**FOUNDATIONS AND OIL CONTAINMENT FOR  
AIRSIDE, WESTFORK, AND BALLOU SUBSTATIONS**

**Pre-Bid Meeting Notes**

**Wednesday, January 18, 2023  
1:30 p.m., E.T.**

DWG. NO. 130

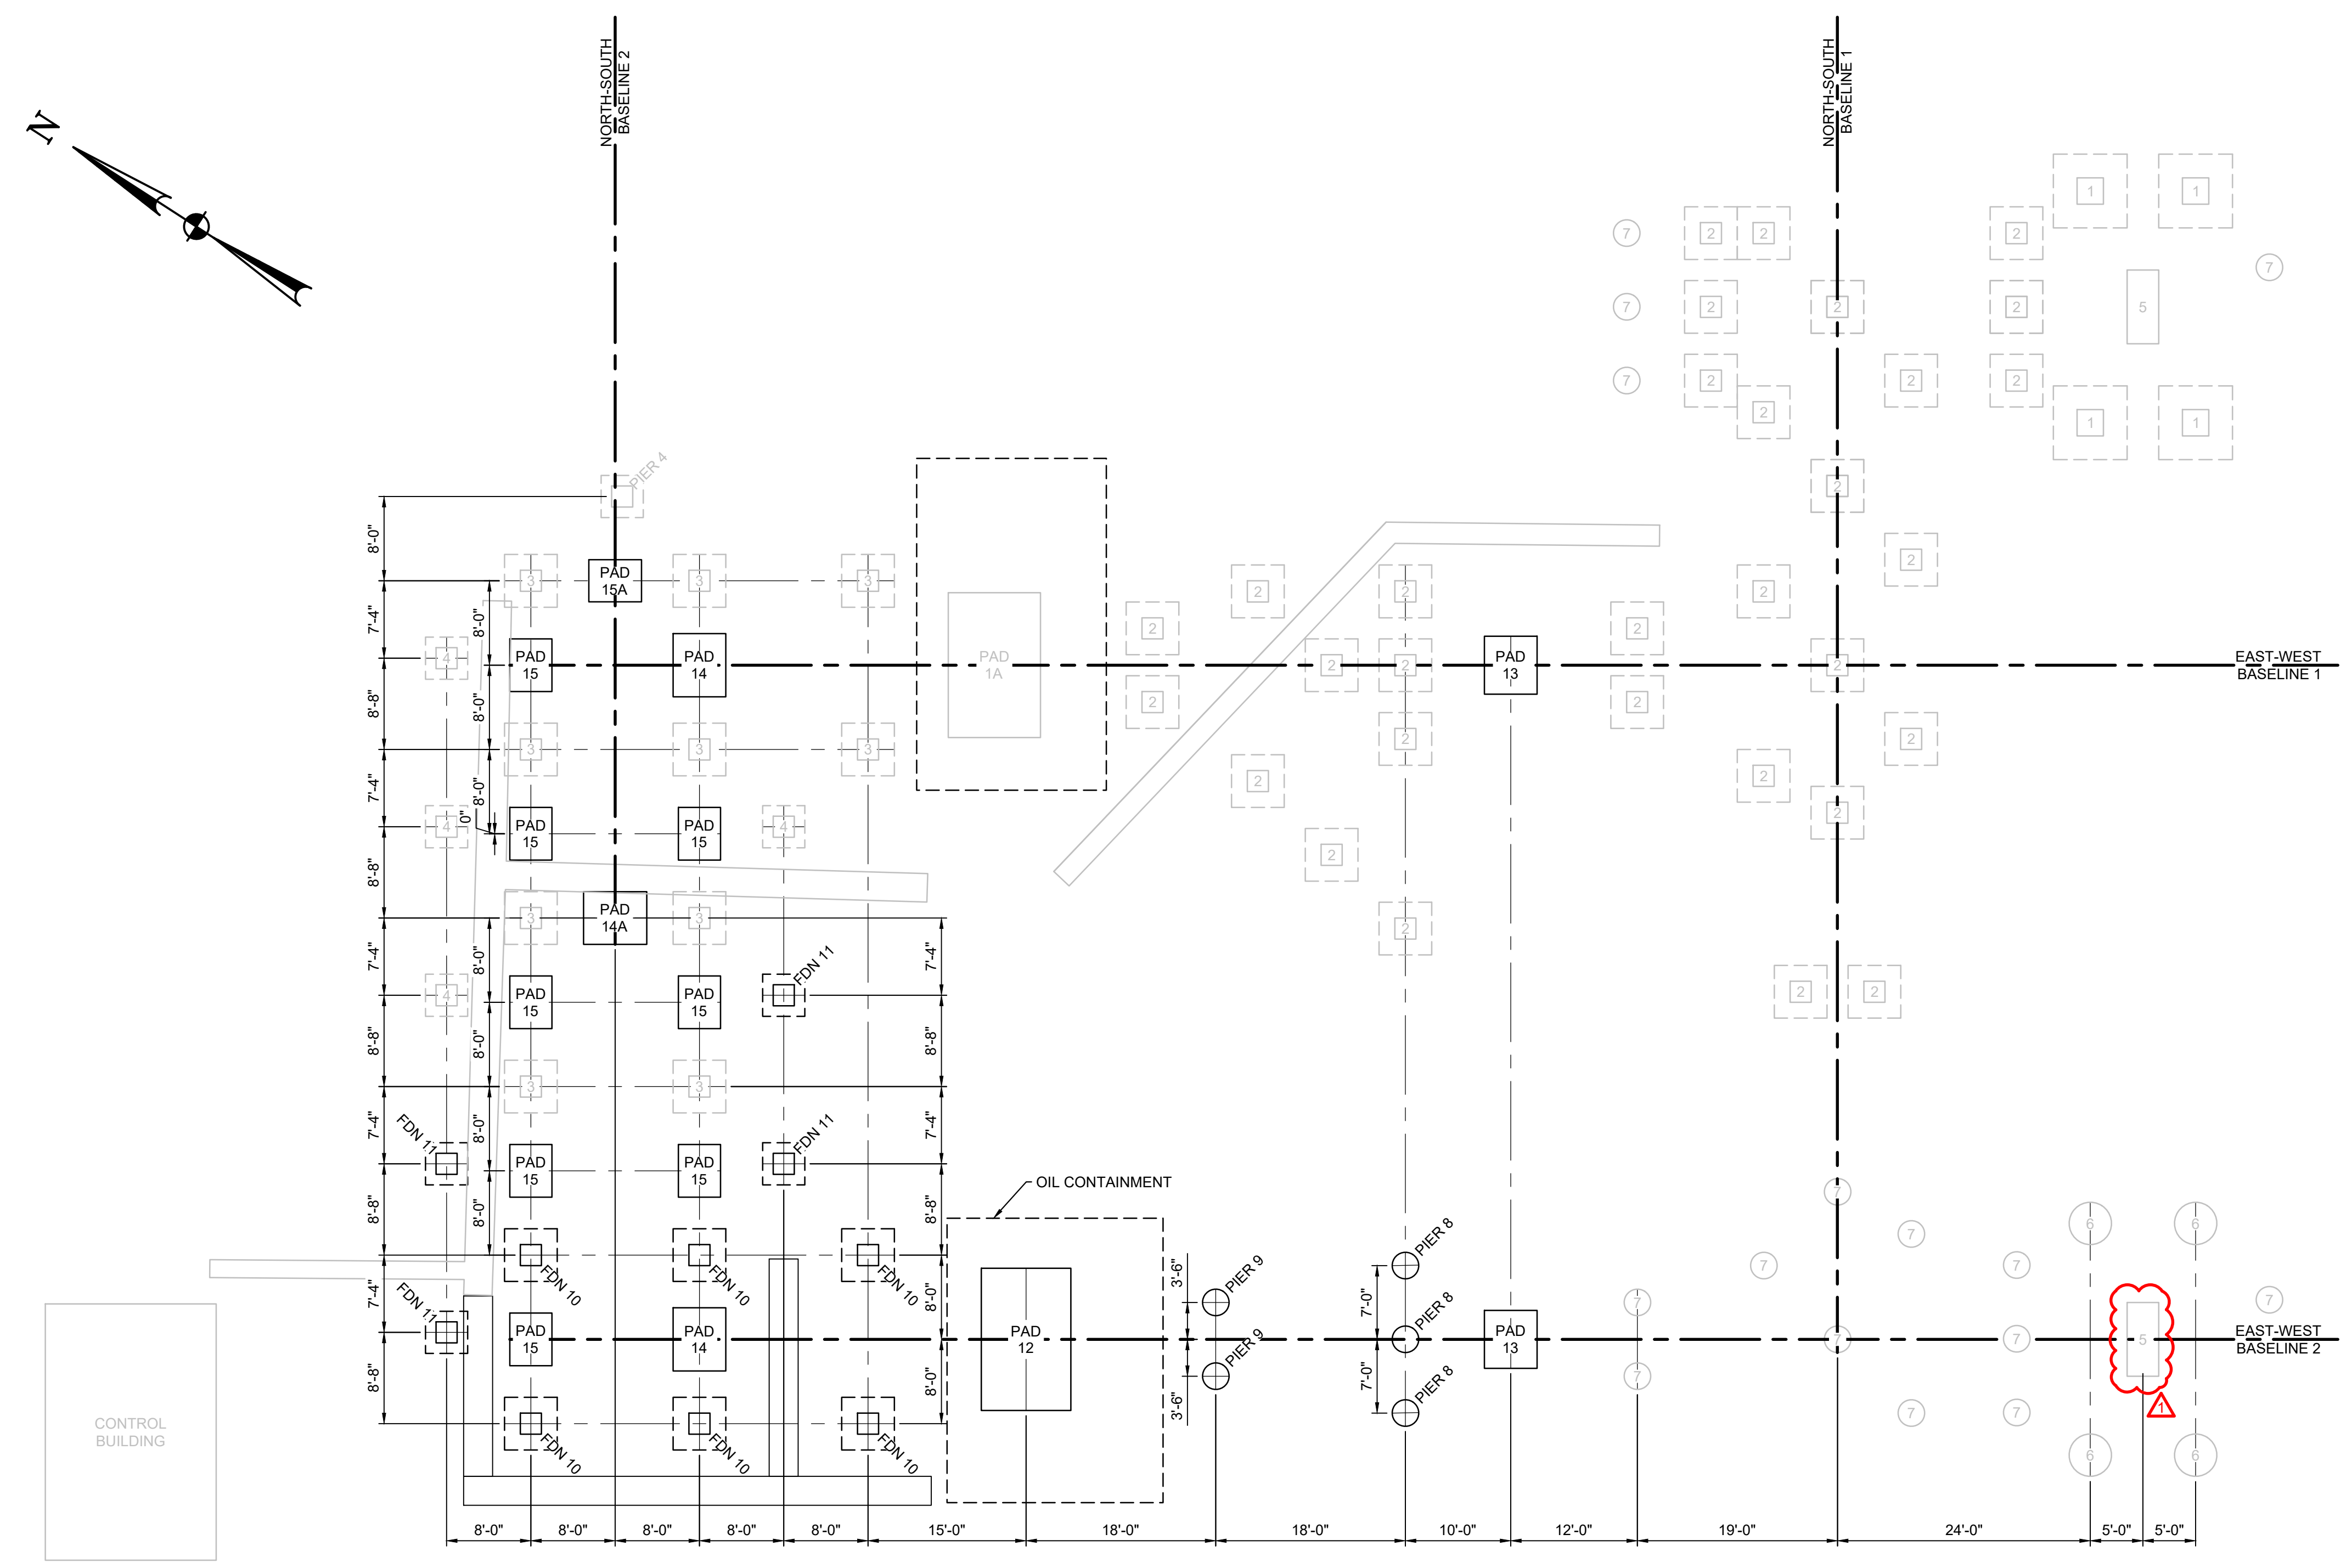
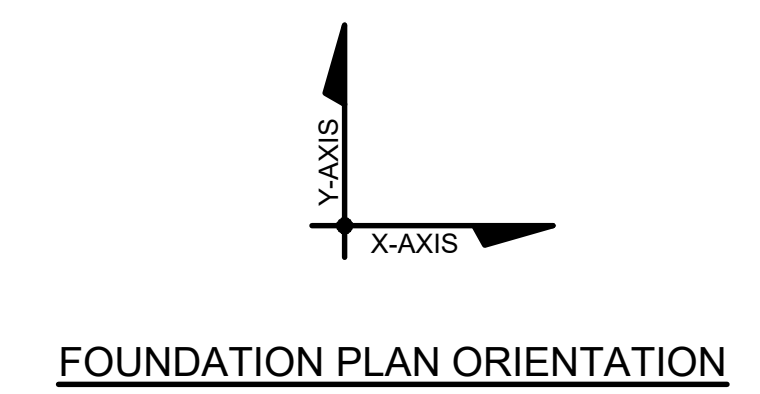
14. Revised new foundation drawings for Airside are attached. Unfortunately, no foundation drawings for Ballou or pad foundation detail drawings for Airside are available.

REV	DATE	DESCRIPTION
0	12/23/22	ISSUED FOR BIDS
1	1/20/23	REMOVED ONE OF PAD 13s

PAD No.	TOTAL REQ'D	PAD SIZE		ANCHOR BOLT PLAN	CU. YDS. CONCRETE	
		LENGTH x WIDTH	DEPTH		PER FDN.	TOTAL
12	1	13'-6" x 8'-6"	5'-0"	N/A	21.25	21.25
13	2	6'-0" x 5'-6"	2'-6"	"E"	3.06	6.12
14 & 14A	3	6'-0" x 5'-0"	2'-6"	"F"	2.78	8.34
15 & 15A	9	5'-0" x 4'-0"	2'-6"	"G"	1.85	16.65
